ROUNDEL HOMES INC. (PH-2)

PROJ. No. 23-01

LOT No. 76

CURRENT DRIVE

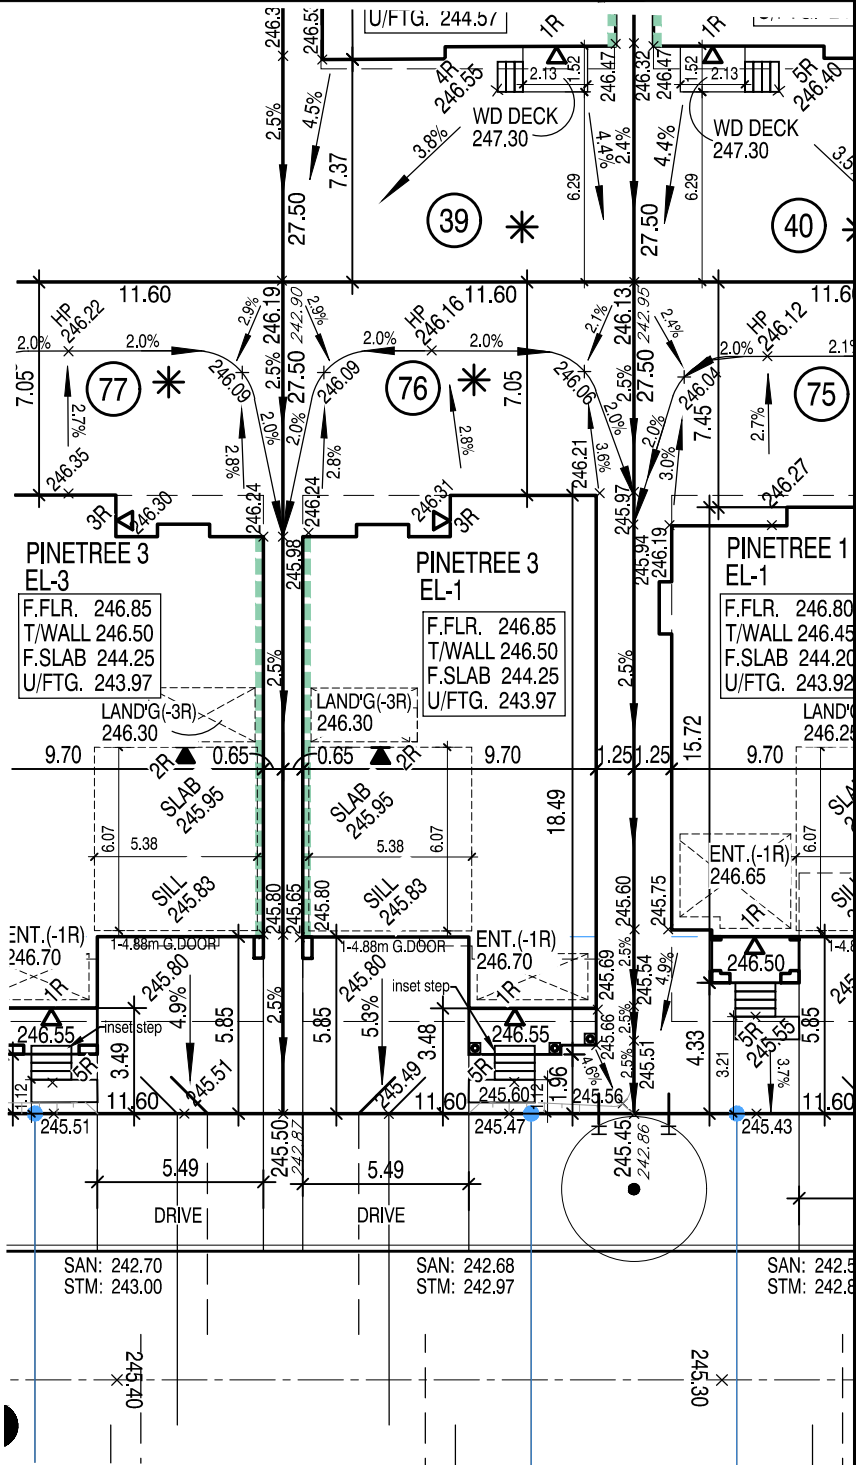
No unprotected openings permitted within 1.2 metres of the lot line as per 9.10.14 of the Ontario Building Code.

45 MINUTE RATED WALL WITH SIDE YARD < 1.2m
